SERVICE BULLETIN

M-870A (Replaces Service Bulletin M-870)

May 10, 1983

NEW VALVE GUIDES FOR XL SERIES TRANSMISSION MAINSHAFT SHIMS IGNITION MODULE /SENSOR CONNECTORS

Figure 2. XL Shoulderless Valve Guide Driver Set

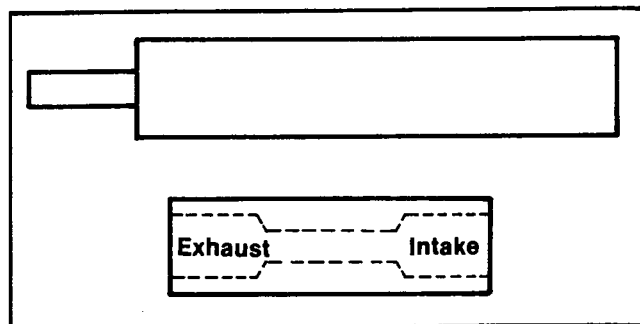
Because the new style valve guides do not have a shoulder, a special two-piece VALVE GUIDE DRIVER SET, Part No. HD-33871, Figure 2, must be used for guide installation to obtain the proper installed height. See Figure 3.

Figure 4. Valve Train Components

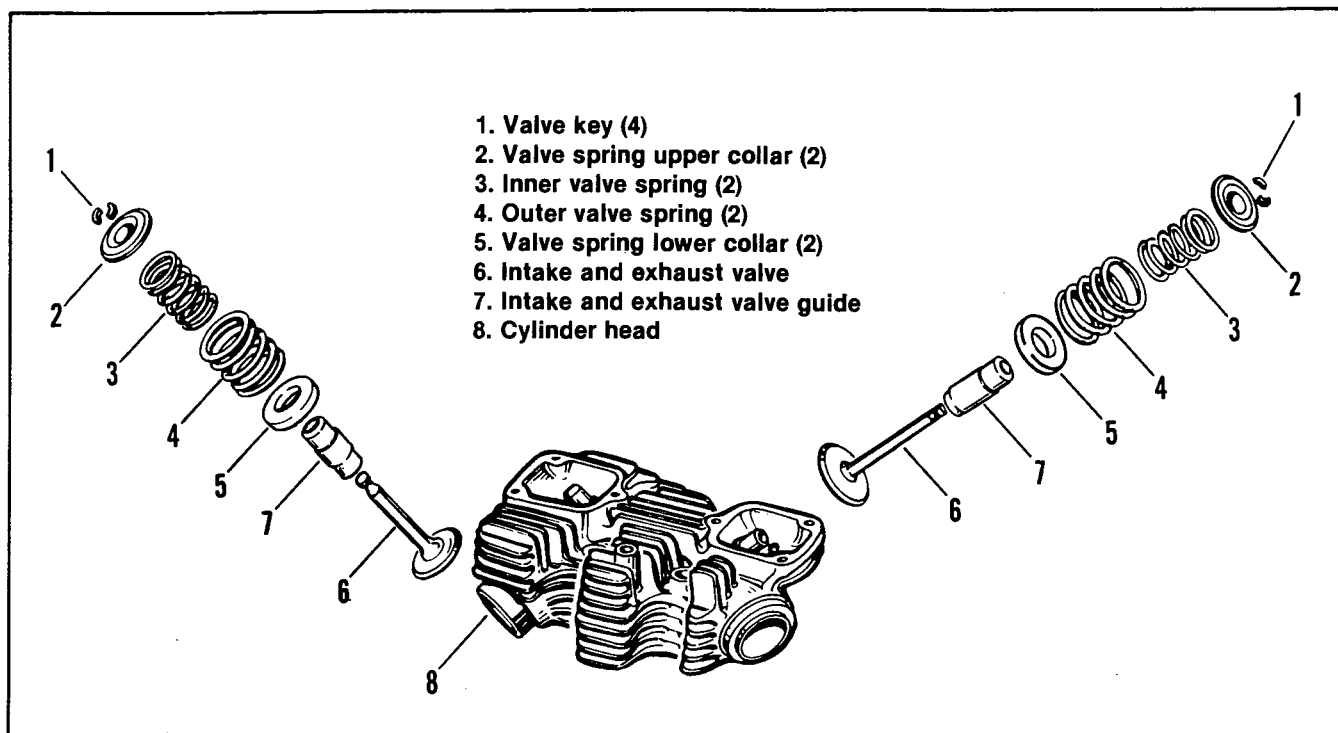
PROCEDURE (Figure 4)

1. After removing the valve keys, valves, collars and springs, heat the cylinder head and drive the old valve guides from the head with a hammer and drift pin.
2. Install the new valve guides using VALVE GUIDE DRIVER SET, Part No. HD-33871. Place the correct end of the tool over the guide and drive the guide into the head until the tool bottoms on the head.

New lower collars and new valve springs must be used together to properly locate the valve springs and prevent the possibility of coil bind.

Figure 5. Mainshaft Thrust Washer

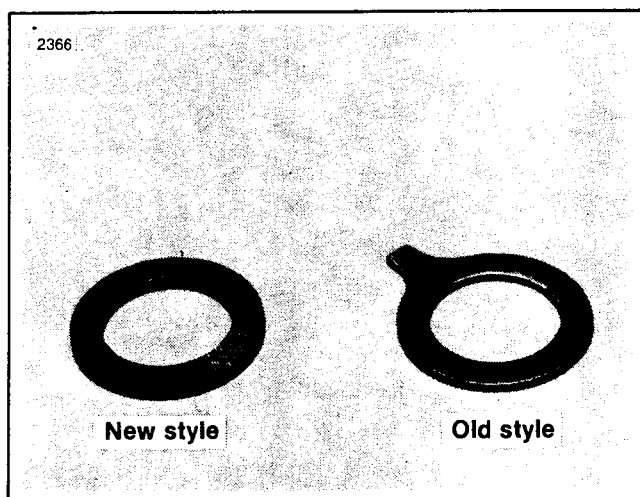
A production change, modifying the method of controlling transmission mainshaft end play, is being incorporated on late 1983 XL series motorcycles. The new style thrust washer, Figure 5, is thicker than the old style thrust washer, allowing the use of one washer where two were previously required. Also the tang used to prevent full rotation of the washer has been eliminated as has been the rollpin in the crankcase, Figure 6.

The new thrust washers are available in four thicknesses; 0.098 inch, 0.107 inch, 0.116 inch, and 0.125 inch. A single new washer can replace the earlier style thrust washers if the end play is great enough to require the use of the new thicker washers.

Figure 8. Ignition Module/Sensor Connector Halves

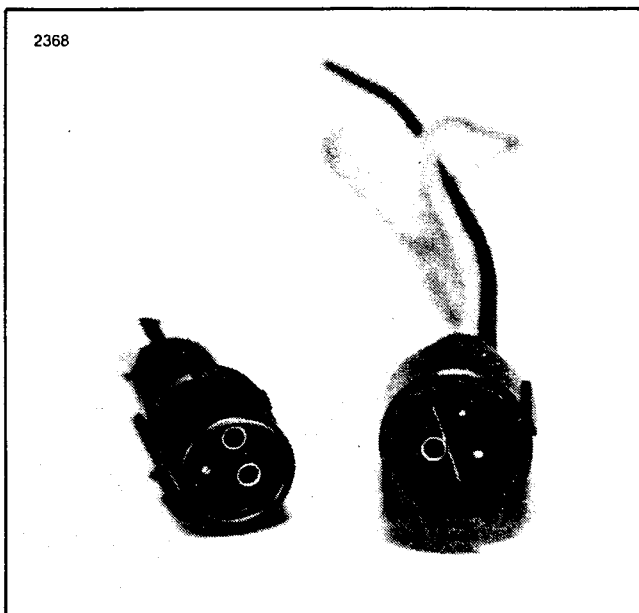
Late 1983 XL ignition modules Part No. 32410—84 and sensor assemblies Part No. 32400—80 are being manufactured with rubber rather than plastic connectors. This change is being made to improve component service life and to avoid possible separation of connectors in the field. When servicing early 1983 ignition systems, always check the module/sensor connectors for tight fit.

The late 1983 XL modules and sensors will interchange with the early 1983 XL modules and sensors, but will require replacement of the mating connector half if only one component is replaced. Rubber receptacles with 2 sockets and 1 pin or rubber plugs with 2 pins and 1 socket, (Figure 8) are available through Parts and Accessories.
